**Flood Control Project Maintenance  
Levee Inspections****LMA District Cover Sheet****Spring 2016 Levee Inspection Results****Reclamation District No. 0501 Ryer Island**

**Spring 2016 Levee Inspection Results**

**Reclamation District No. 0501 Ryer Island**

Photo 1 of 2 : UCIP\_SP\_2016\_44720\_73904.jpg

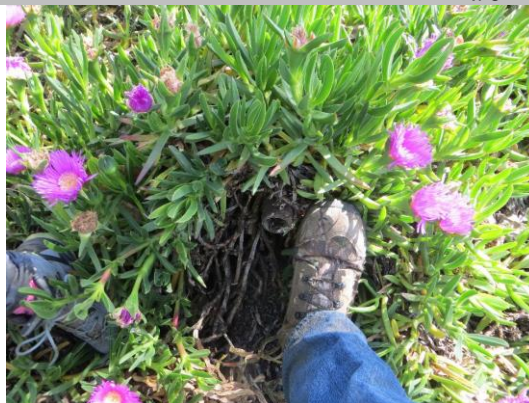
LM Start	4.57	Rating **	M	Issue No.	993
LM End	4.57	Issue Type +	En	Location *	LS
Category	Supplemental			GPS Latitude/Longitude	
				Start	End
Item	DWR UCIP Field Study			38.194438 °	38.194438 °
				-121.623063 °	-121.623063 °
DWR ID					
Comment Code					
Inspector Comment					
FS_ID:44720 DS_ID:21103 EP_NO: N/A Repair Type: Non-Urgent Crossing Status: Indicator Found UCIP Comments: Need to verify type of abandonment and if needed abandon it properly. FIELD_STRUCT_DESC: *ABANDONED* 12-inch pipe through the levee, 3.0 feet below the crown. (USACE-1959). This entry matches the Drainage or Irrigation Structure referenced in O&M manual (HLM 4.90). A 1.5-inch electrical conduit is visible on the LS slope 3-feet below the crown (good indicator for pipe crossing). FS Date: 4/21/2015

Photo 1 of 1 : SP\_2016\_RD0501\_169\_1\_20160223\_00001.jpg

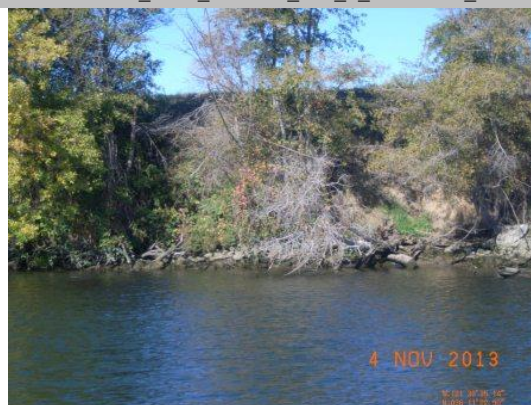
LM Start	5.77	Rating **	M	Issue No.	1
LM End	5.84	Issue Type +	Ma	Location *	WS
Category	Supplemental			GPS Latitude/Longitude	
				Start	End
Item	2015 USACE Erosion Survey, DRAFT			38.190001 °	38.189311 °
				-121.643160 °	-121.643917 °
DWR ID	DWR_RD0501_01_s_2016_1				
Comment Code					
Inspector Comment					
2008 - Overstepped levee section with multiple small pockets of erosion 10 - 20 ft wide. 2013 - Site has fresh erosion and taller vertical sections. 2015: No observed changes. [2015 Site ID: STM_15-7_R]

Photo 1 of 2 : UCIP\_SP\_2016\_32545\_59039.jpg

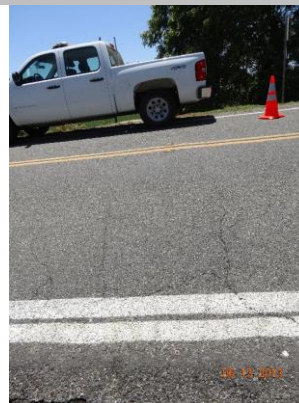
FS\_ID:32545  
DS\_ID:21063  
EP\_NO: 11812  
Repair Type: Urgent  
Crossing Status: Found  
UCIP Comments: Open cut section of levee on LS slope 8 foot wide-- repair work needed. Abandoned pump on waterward berm. Dense vegetation--Recommend removing vegetation along pipe alignment to conduct proper inspection of structure and appurtenances on waterward side.  
FIELD\_STRUCT\_DESC: 14-inch steel pipe and 1.25-inch electrical conduit through the levee, both 3.0 feet below the crown. Cutoff wall around pipe and conduit at center of levee. Siphon breaker on apex of pipe at landward shoulder. Slant pump on waterward slope. Discharge structure at landward toe. Rock revetment on waterward slope. (Permit No. 11812-1976)  
FS Date: 6/7/2013

Photo 1 of 2 : UCIP\_SP\_2016\_32546\_59047.jpg

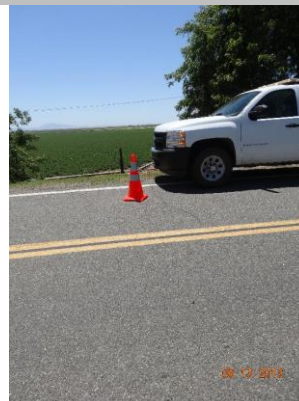
Comment Code					
Inspector Comment					
FS_ID:32546 DS_ID:21064 EP_NO: N/A Repair Type: Non-Urgent Crossing Status: Found UCIP Comments: Debris (pipe section) located on waterward berm. Dense vegetation limits the inspector's visibility to identify signs of pipe failure (leaks) along the waterward slope. Recommend removing vegetation along pipe alignment to conduct proper inspection of structure and appurtenances. FIELD_STRUCT_DESC: 8-inch steel pipe through the levee, 2.7 feet below the crown. Pump in pump house at landward toe. (USACE-1959). This entry matches the Drainage or Irrigation Structure referenced in O&M manual (HLM 8.20). FS Date: 6/13/2013
